RE: Town of Jackson Wastewater Lagoon, Permit No. WY0021458

On behalf of Protect Our Water Jackson Hole (POWJH), I am pleased to submit this letter in response to the WDEQ's September 16, 2022 public notice inviting comments on the above-referenced pollution discharge permit renewal.

I. Flow Diagram

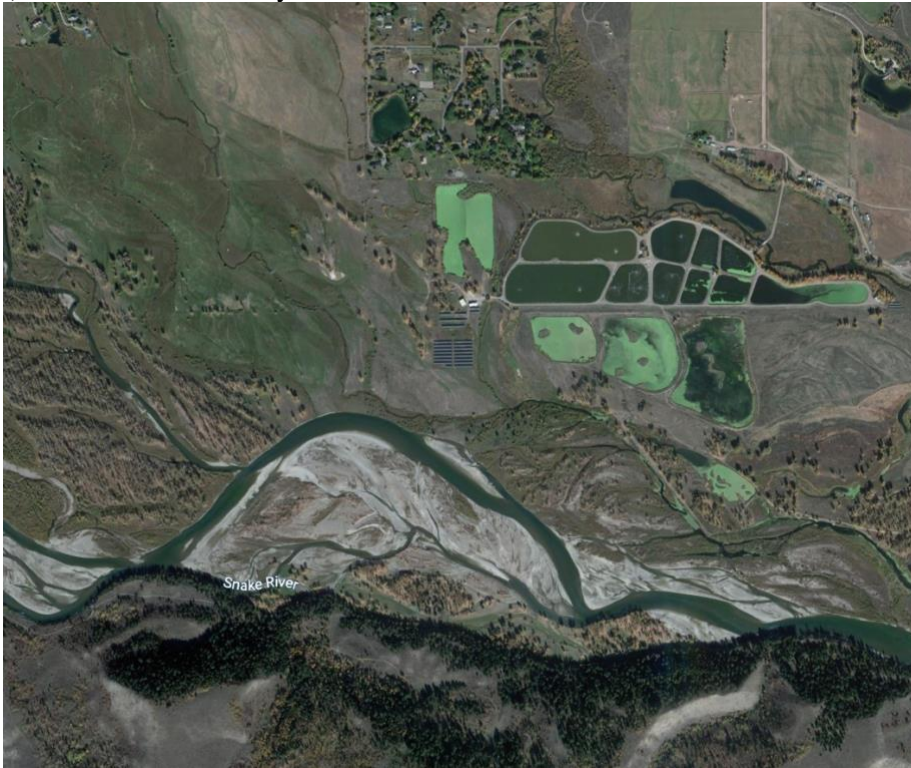
- a) It would be helpful for the public to understand the flow of effluent through the facility by illustrating a flow path with a simple arrow through each pond/facility component.
- b) It appears that the unnamed tributary below the borrow pond, that receives effluent from this facility, either contains or could support fish (and would therefore be considered Class 2AB). What evidence does DEQ have indicating this segment does not contain fish and other aquatic life?

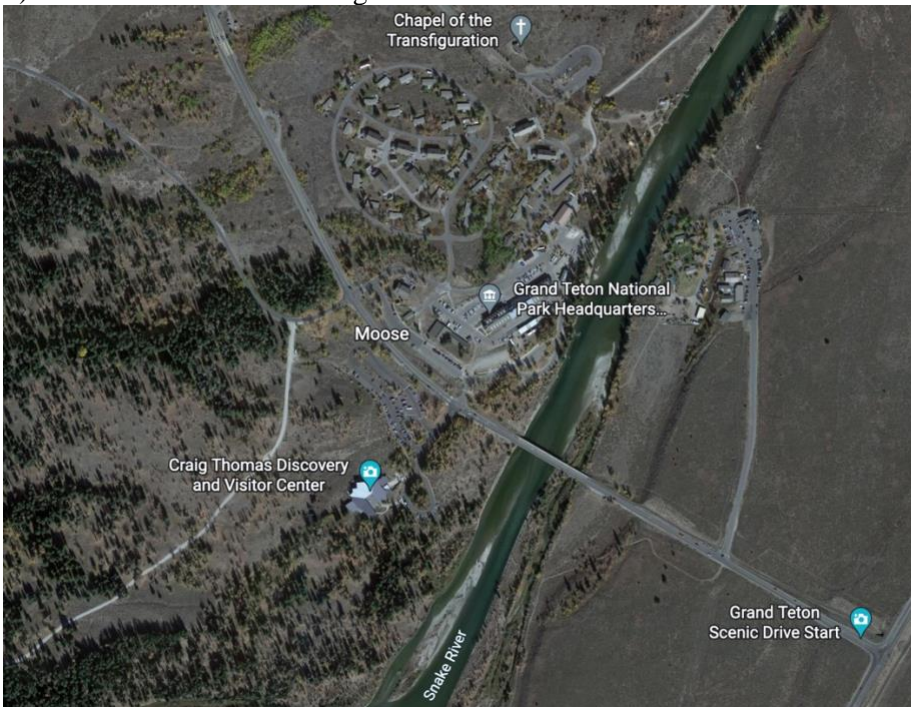
- a) Flow data from the Moose gauge is used to justify the exclusion of an official mixing zone. As evidenced by the included pictures (Google Earth), the nature of the Snake River near the facility (i) is different than at the Moose Gauge (ii). How are the braided nature and variance of flows in the Snake River taken into account when calculating dilution?
- b) This permit states (on Statement of Basis page 5) that water quality based effluent limits for ammonia are being established per mixing zone rules, but this statement appears to be inaccurate as no effluent limit exists for ammonia.

i) Snake River at facility

ii) Snake River at Moose Gauge
